SUBMISSION

PUBLIC EXHIBITION

CARTER ST URBAN ACTIVATION PRECINCT

Figure 1 Comparison of proposed residential development in Sydney Olympic Park and Carter St UAP.

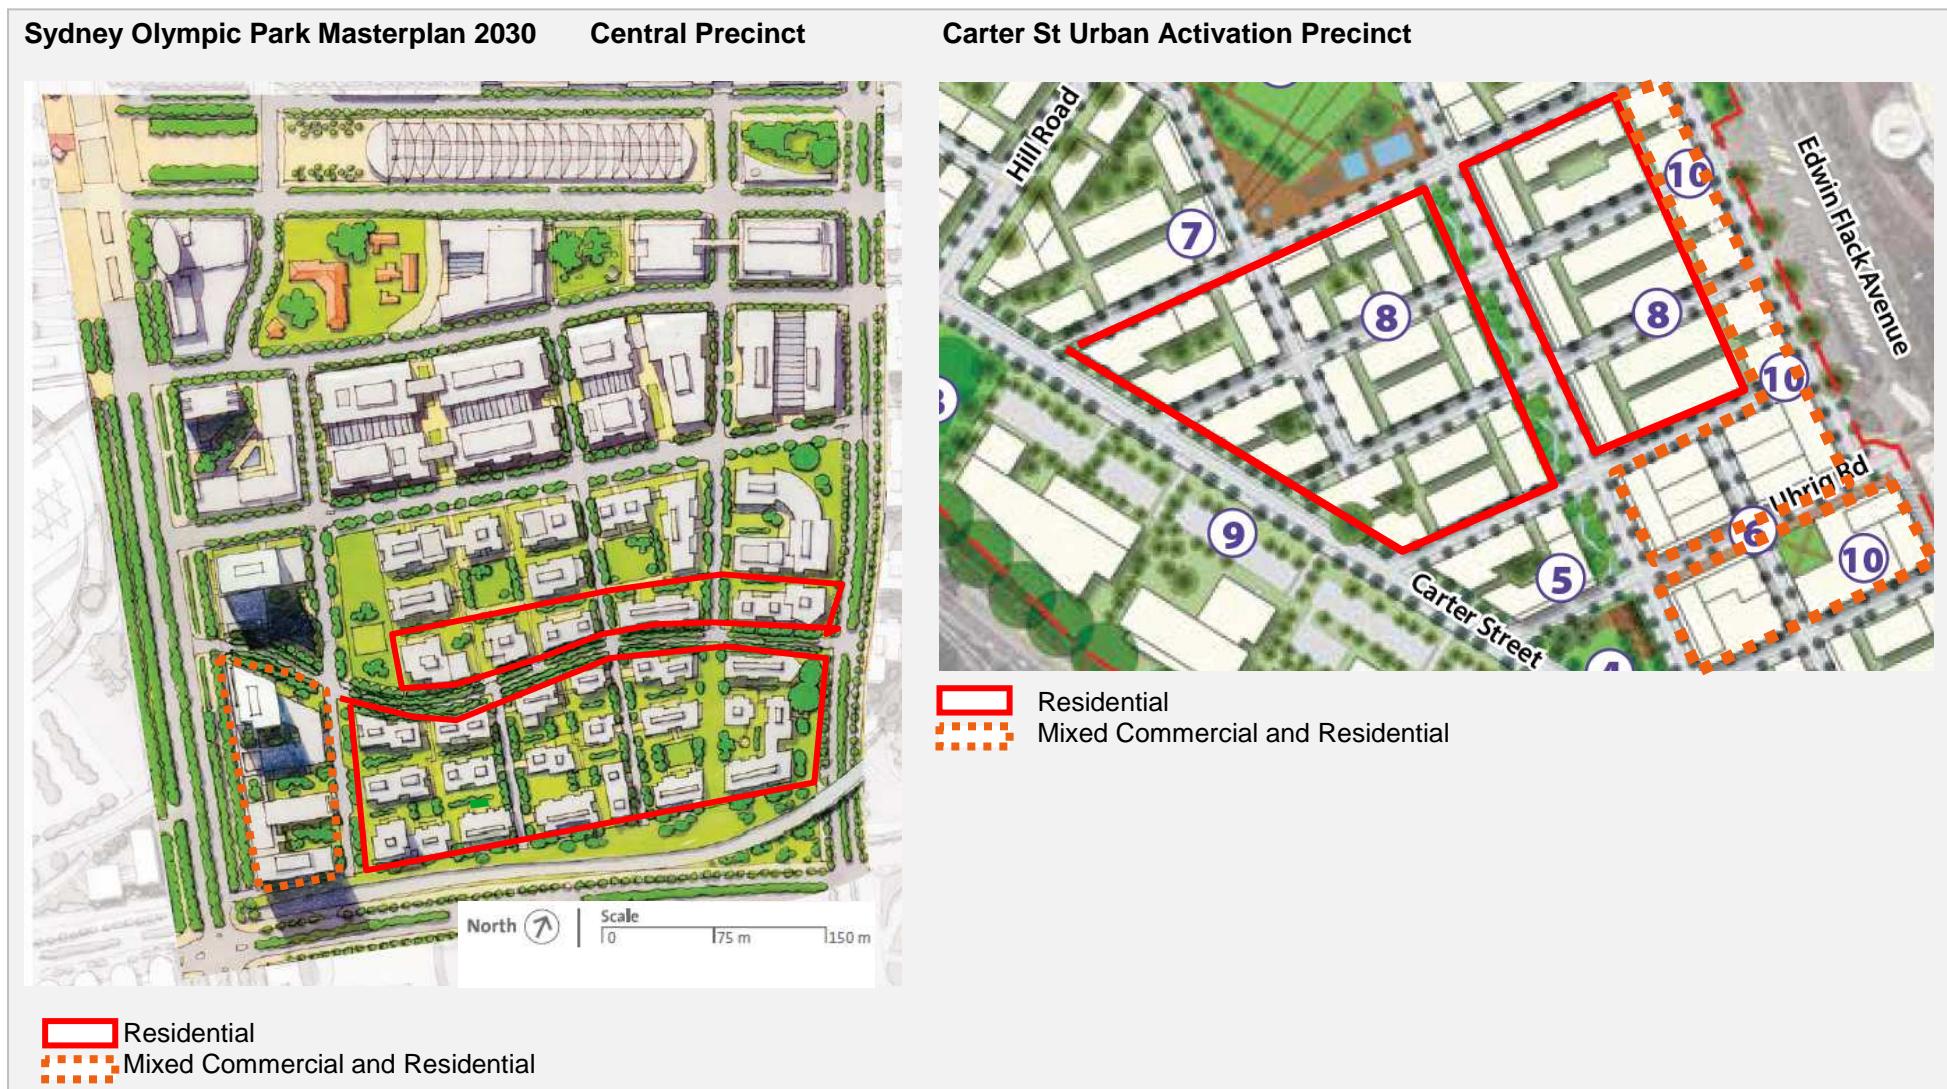
Given that the site is seen, in part, as an extension of Sydney Olympic Park, it is instructive to compare the residential components under the *Sydney Olympic Park Masterplan 2030* with the proposed main residential areas in the Carter St UAP as shown in Figure 1.

As illustrated in Figure 1, the precinct close to the station, that is Central Precinct within the Olympic Park site, provides for greater variety in built form, larger communal open space areas, street setbacks and building separation, and more landscaped views from the street to break up the urban space, than the Carter St precinct, further from the station. This is partly as a result of the use of more open built forms in the Central Precinct, rather than the perimeter block forms in the UAP, partly to height differences and partly due to the difference in permitted residential density.
